**Summary of consultation responses**  
**King's Cross Station Enhancement**

**December 2006**

**King's Cross Station Enhancements  
Meeting with Camden 22nd Nov, Extract Ventilation**

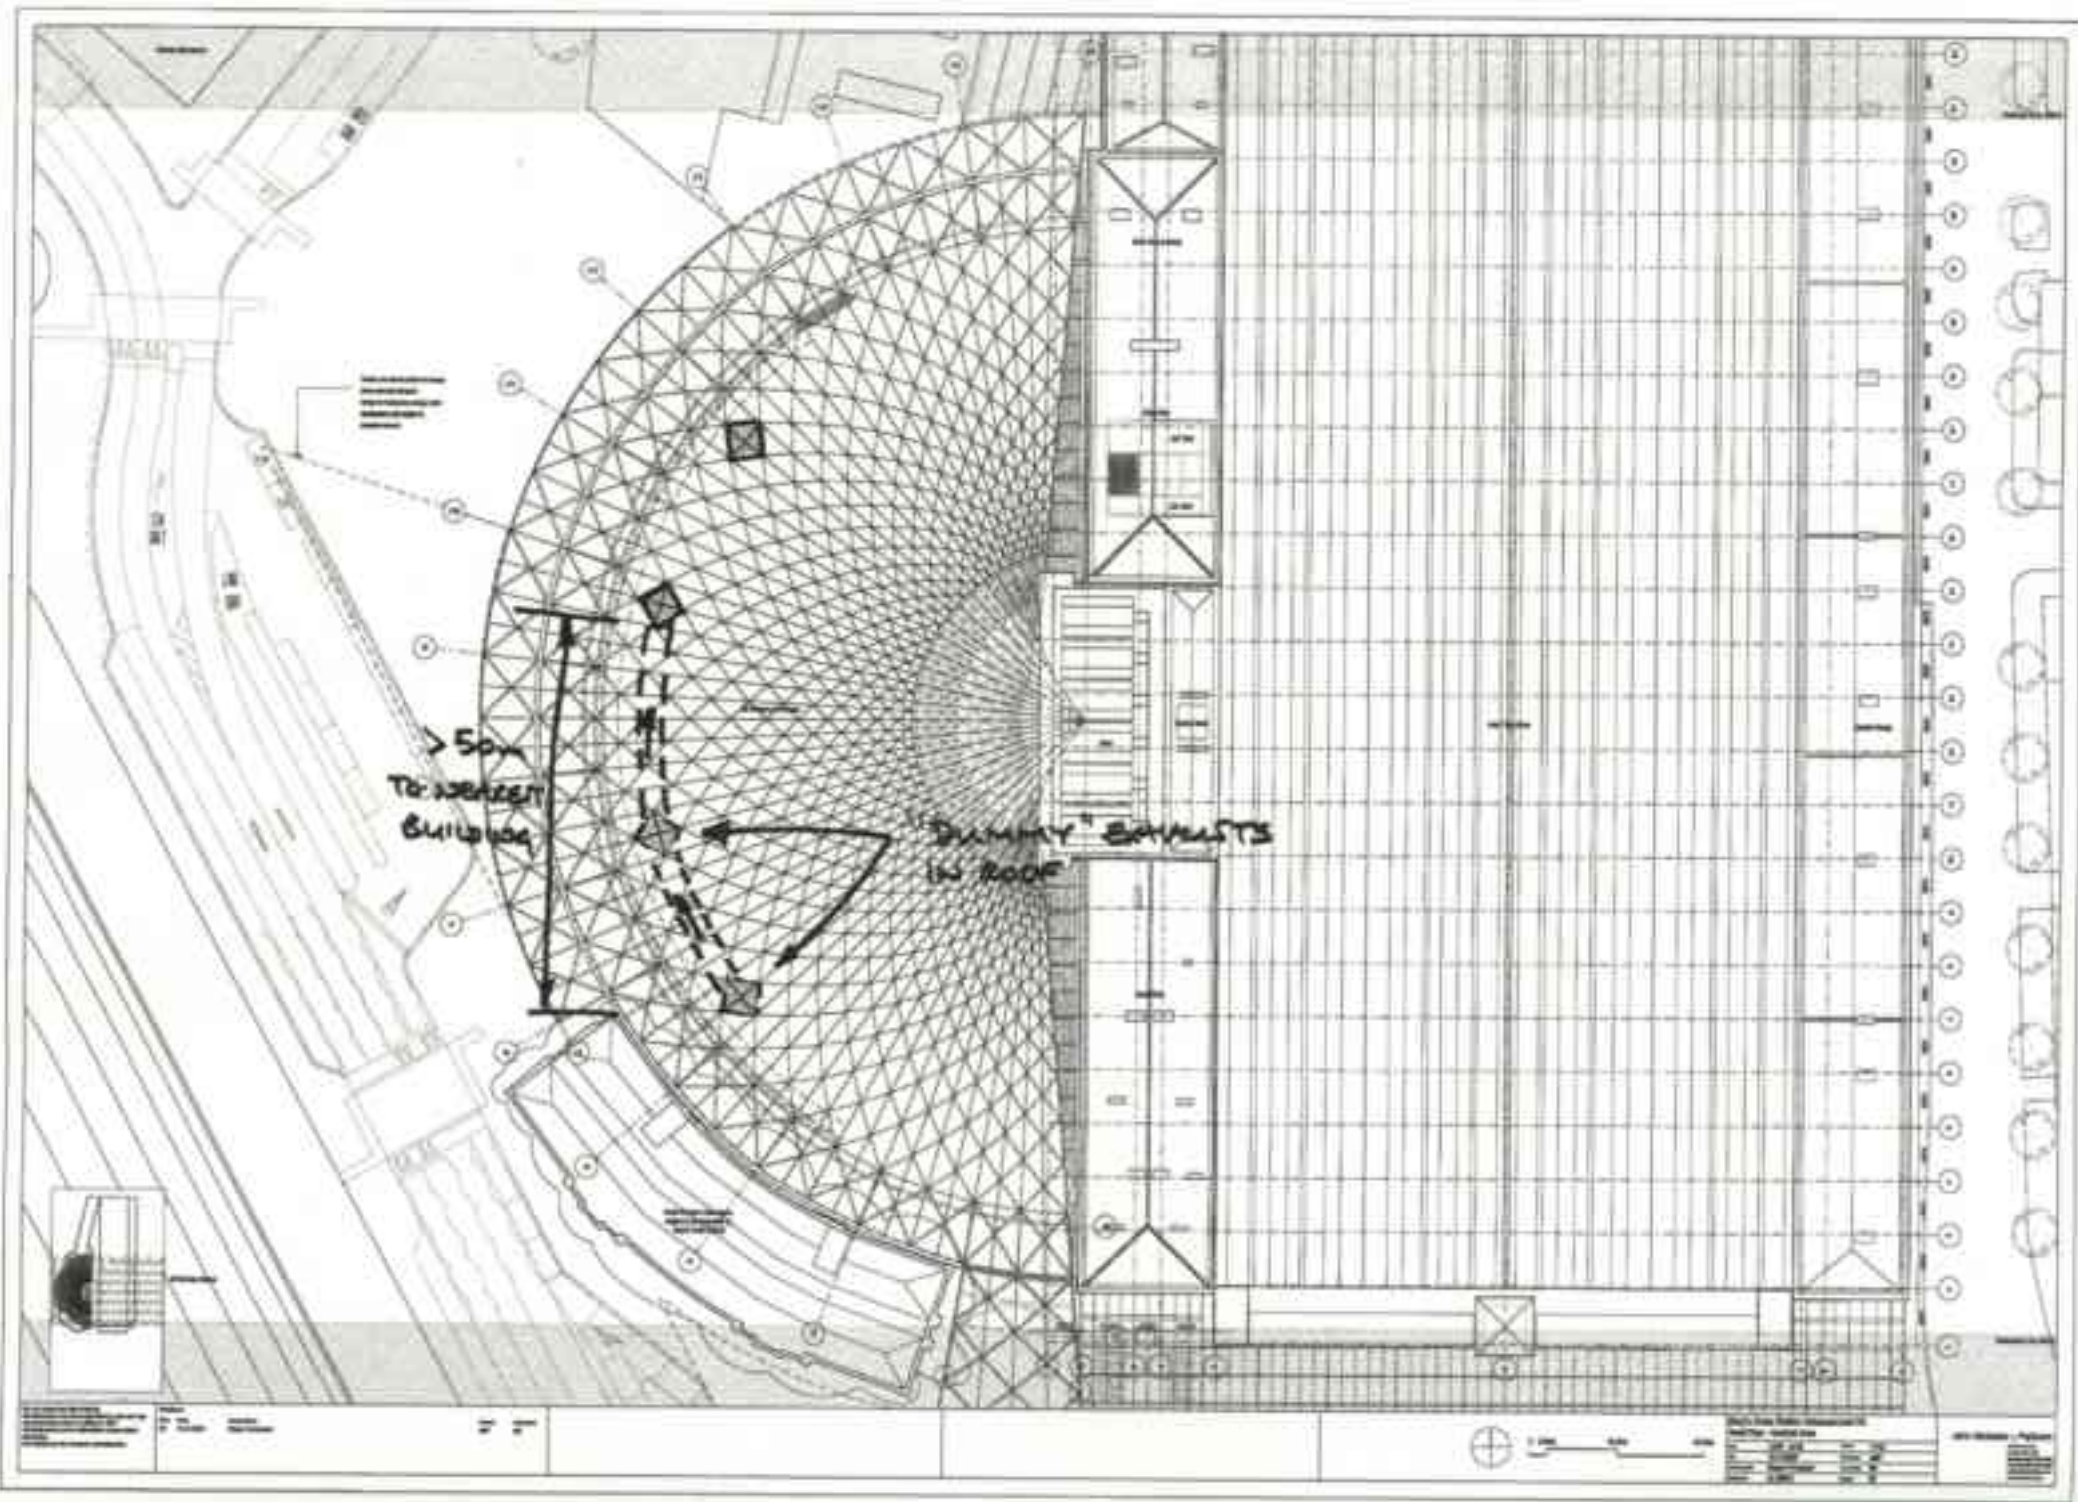
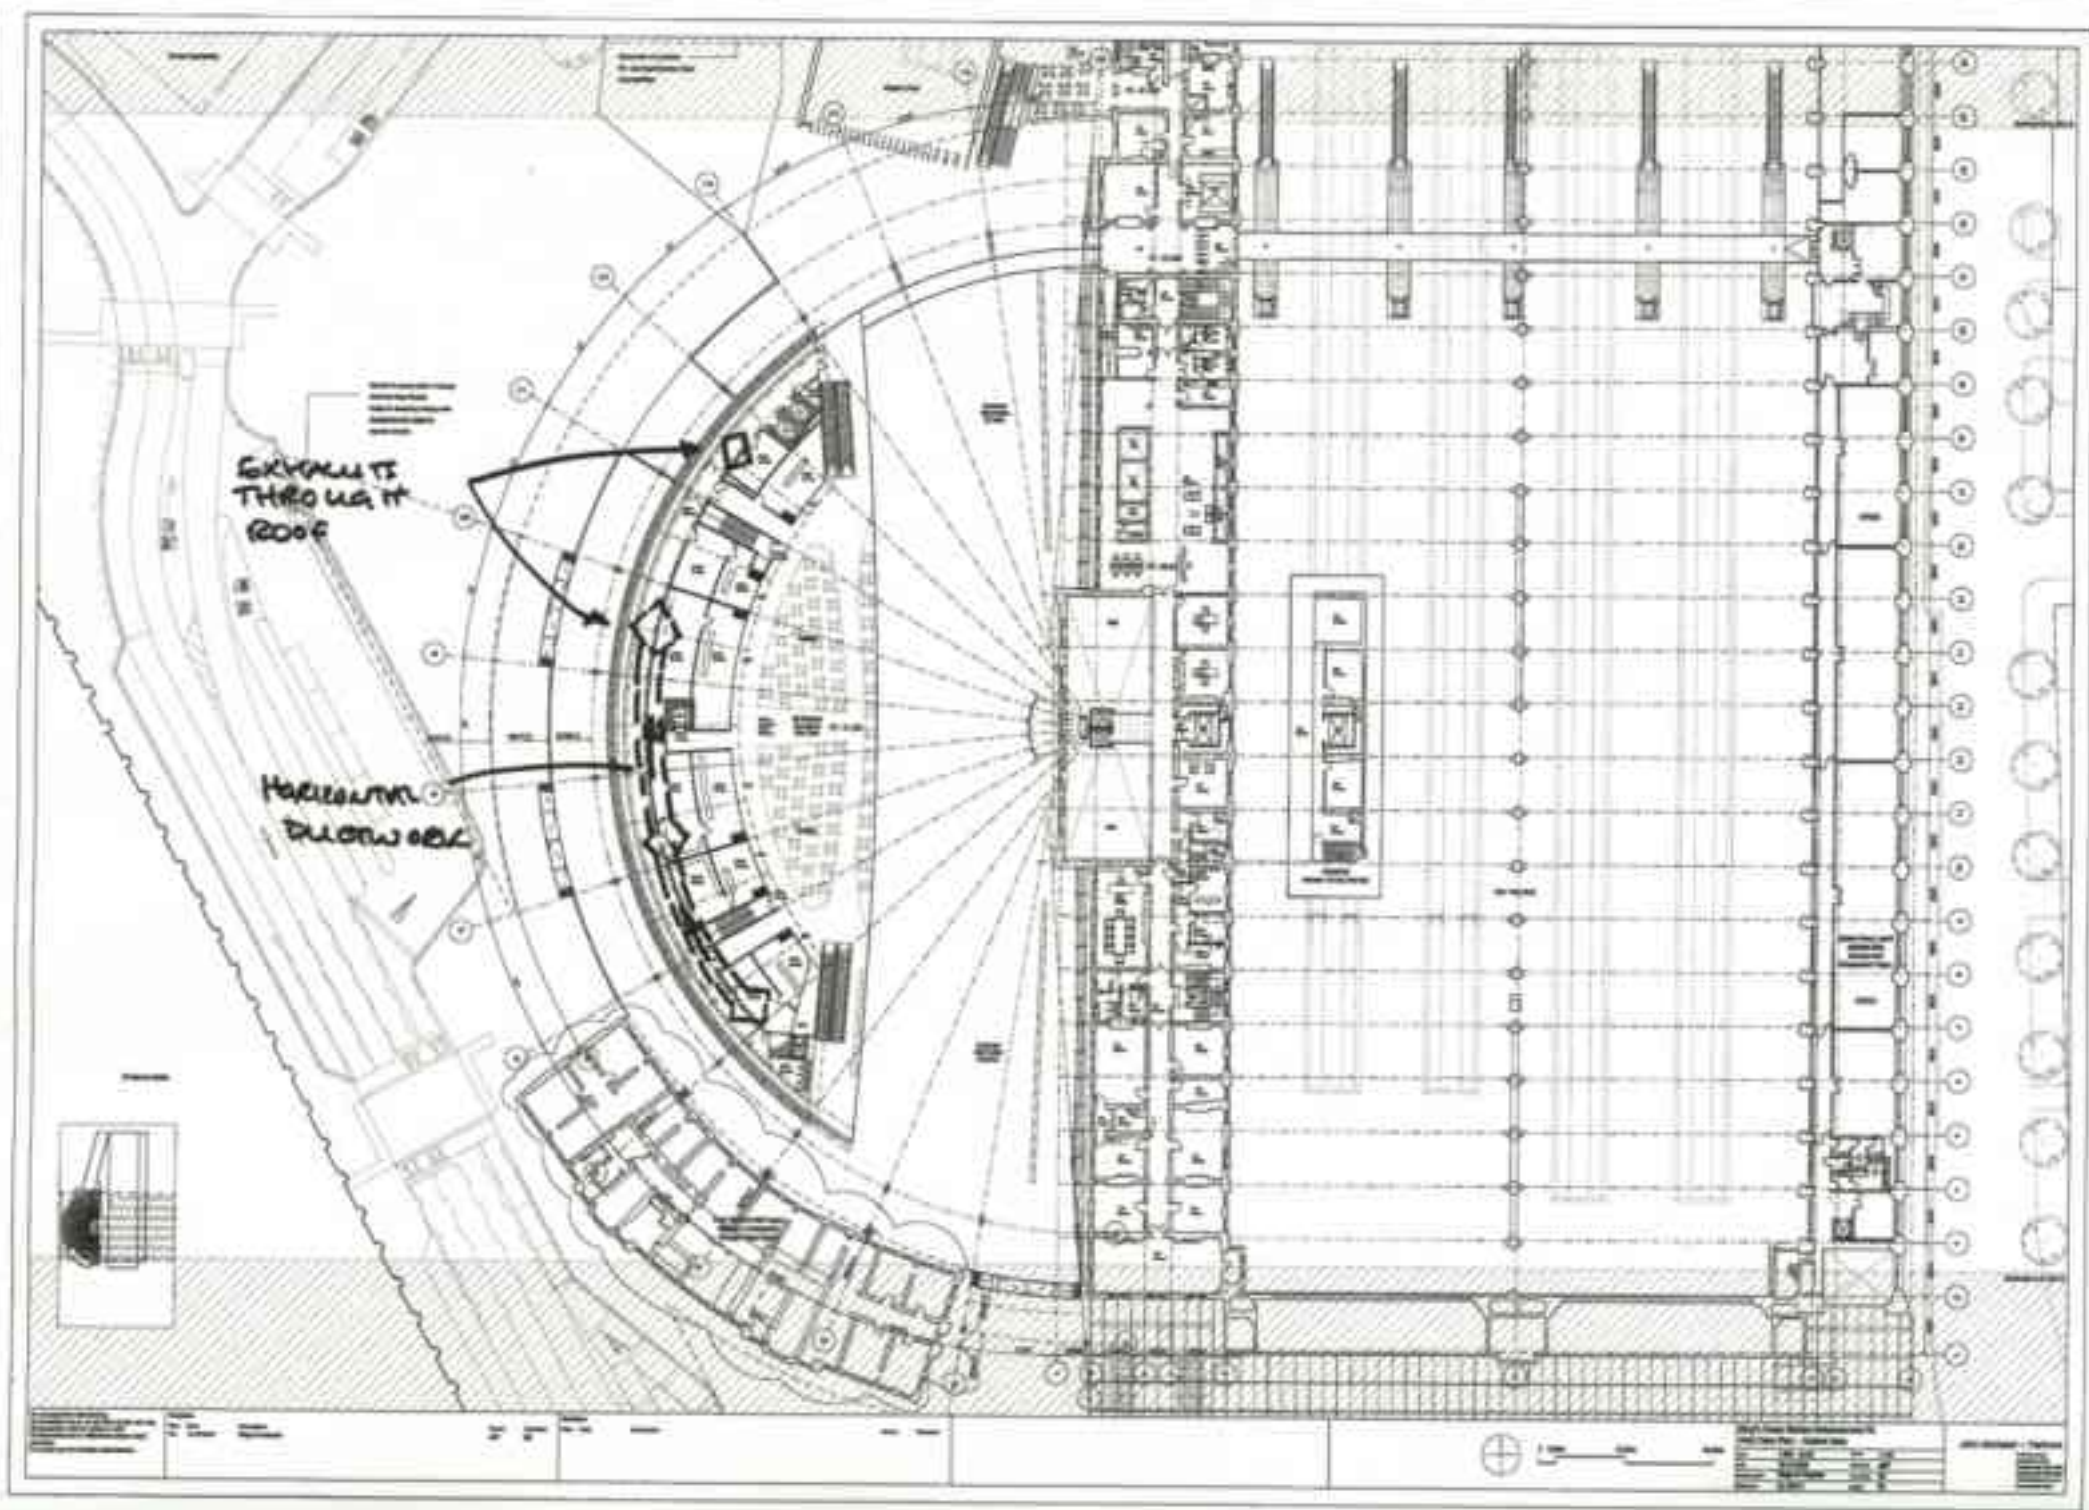
We discussed Camden's concerns over the 4 extract louvres shown on the roof plans, and their suggestions of ducting the extracts to high level. We pointed out that their suggestions of tall flues to the roof level of the Great Northern Hotel or lengths of extract ductwork following the curve of the roof would not be acceptable architecturally. In addition, long lengths of duct for kitchen extract would accumulate fat and pose a fire hazard.

The low level ventilation identified on the concourse roof is not acceptable because of likely odour nuisance in the vicinity, particularly adjacent to the upper floors of the Great Northern Hotel. It is Council policy that a high level extract duct should be provided above the roofline of the subject building and where possible, to adjacent buildings. A re-worked design for the ventilation will be required as part of the current assessment.

The council appeared to want flues extending up to GNH roof line, and was suggesting runs of ductwork along the concourse roof. The architect does not want this as it spoils the appearance of the building. The current architectural layouts and models show a smooth roof surface, with extract vents flush with the roof. At the meeting, Camden's Environmental Health Officer accepted that flues above the roof, especially if they are to extend to the roof level of the GNH, would not be architecturally acceptable. He also accepted that the long ductwork runs suggested in the second paragraph above would collect fat and be a fire hazard, and in any case, they detract from the architecture.

We explained that we want to maintain the appearance of the roof as currently shown on the plans, and in order to satisfy the planners we would not be extracting odours at the two extracts closest to the Great Northern Hotel. The extracts would also have deodorising filters - our *Retail Engineering Services Strategy* report (54200/159/1, Nov 2003) states: "it is recommended that major catering tenants are required to fit UV or deodorising washer type filters to the kitchen exhausts". We tabled sketches (attached) showing an option for achieving this by making the southern vents into "dummy" vents, and extracting only to the two Northern vents. This proposal would impose restrictions on the type of catering provided in the units at the southern end of the mezzanine.

HORIZONTAL DUCTWORK  
TO TAKE EXHAUST AWAY  
FROM SURROUNDING  
BUILDINGS

NOTE: EXTRACTS SHOULD NOT  
EXTEND ABOVE ROOF  
SURFACE. EXHAUST  
PERFORMANCE TO BE  
INVESTIGATED

NOTE: ROOF SURFACE TO  
ALLOW FOR IMPLICATIONS  
OF KITCHEN EXTRACT  
- FIRE PROTECTION  
- CLEANING

Non - KITCHEN CATERING  
- AVOID EXTRACTING FROM  
COOKING (FAT) INTO  
HORIZONTAL DUCTWORK

RETAIL WORK ON THIS  
SIDE TO HAVE KITCHENS

Arup tabled a marked-up ventilation schematic (attached) showing the 2 vents closest to the GNH being dummy vents, and horizontal ductwork connecting the southern retail units to the 2 remaining roof vents. This option was acceptable to the EHO as an alternative to the long ducts and flues above the roof line.
